REQUEST FOR FURTHER INFORMATION RESPONSE DOCUMENT
FOR ADAMSTOWN SDZ PLANNING APPLICATION:
ADERRIG PHASE 3
MARCH 2022

CONTENTS

Site Plan

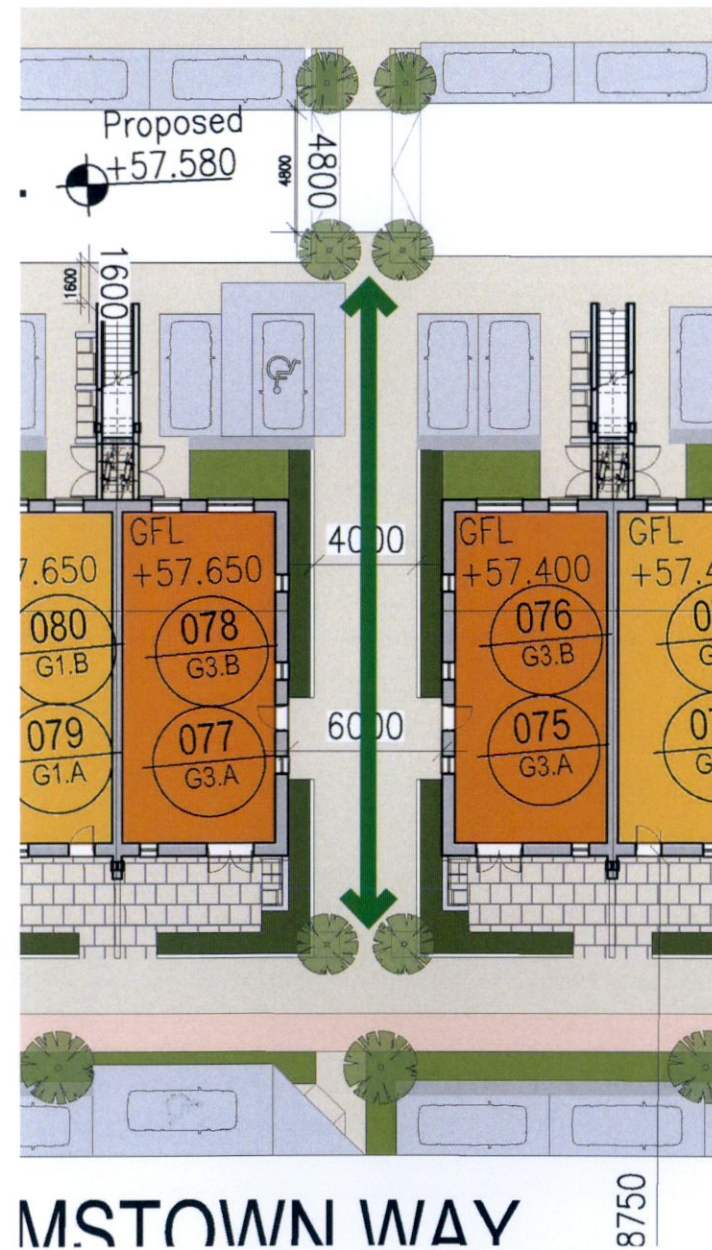
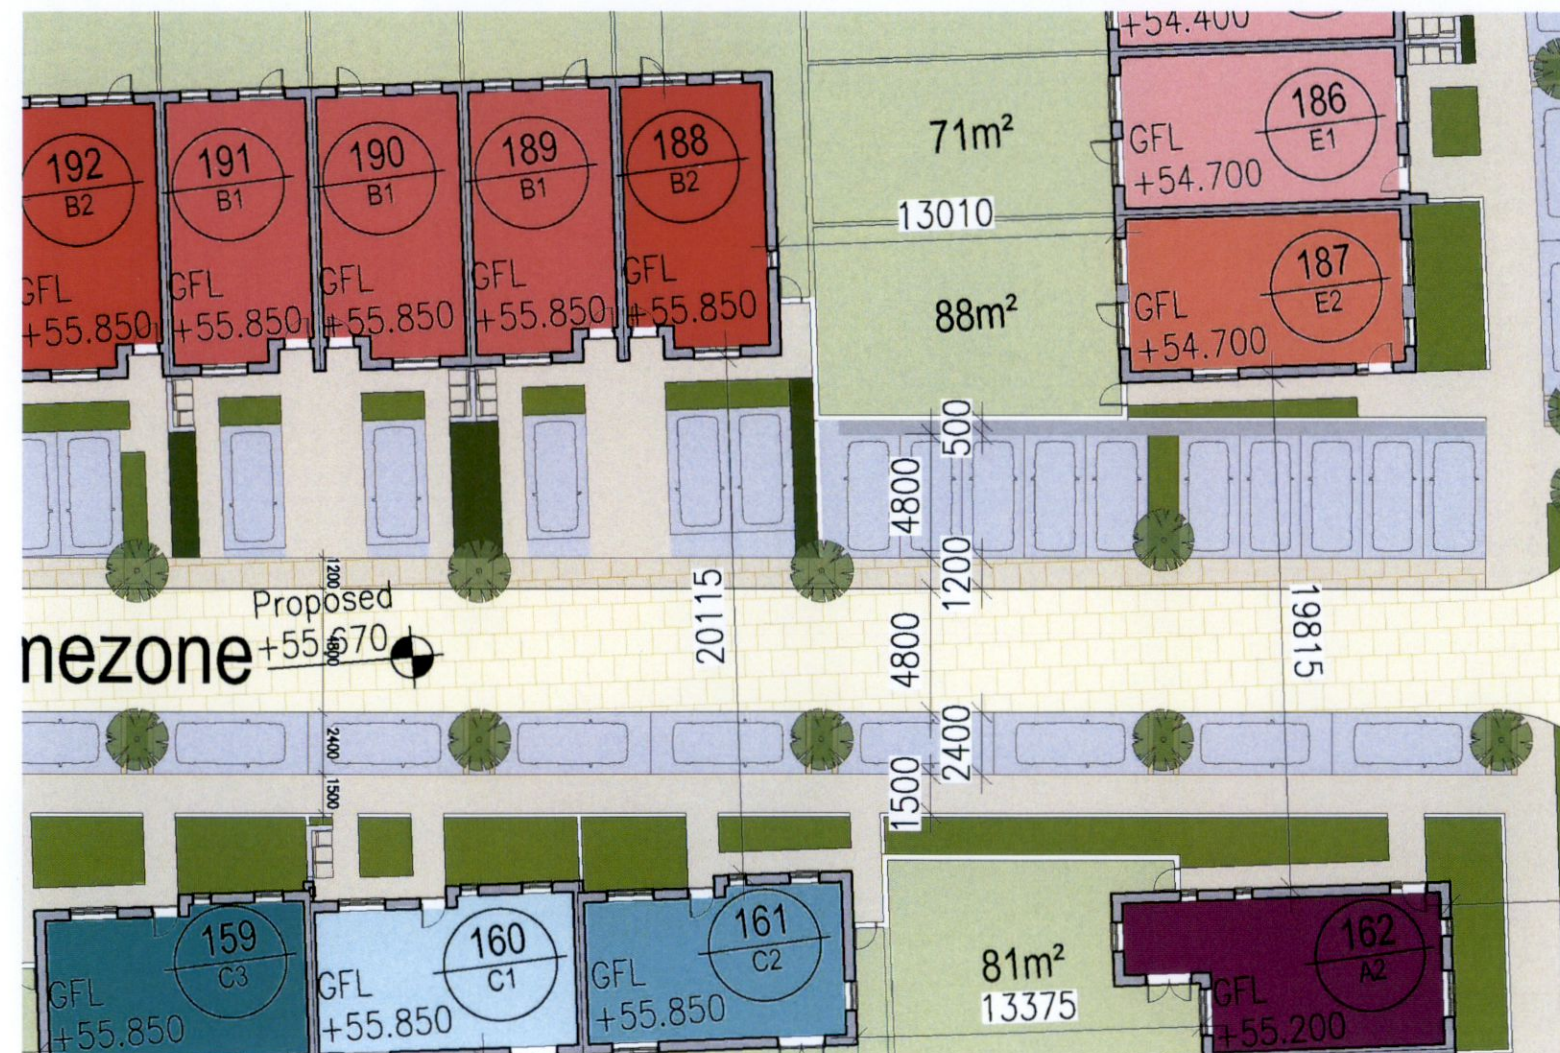
i. Street trees to be provided on all streets in the public realm, integral to the street, outside the footpath on both sides. Street tree provision is deficient along the following streets:

- Road 1 East side
- Road 2 Northside
- Road 3 North side
- Road 4 South side
- Road 5 East Side (retained vegetation to West is noted)
- Road 6 (one)
- Road 8 East side (retained vegetation to West is noted)
- Road 9 North side
- Homezone 2 East side
- Pedestrian link (Links Road 3 to Celbridge Link Road).

The streets have all been adjusted to provide street trees which can be taken in charge on both sides of the road.

The pedestrian routes, as noted do not contain any street trees between buildings so as to allow for ease of movements and also as the location of the pedestrian routes are key service routes through the blocks, which make it impossible to locate tree pits along these routes.

However, street trees have been located at either end of the pedestrian routes where possible along with green buffer zones.

Pedestrian link between Adamstown Way and Road 4.
Trees located to the ends of the pedestrian route along
with green buffers to the sides.
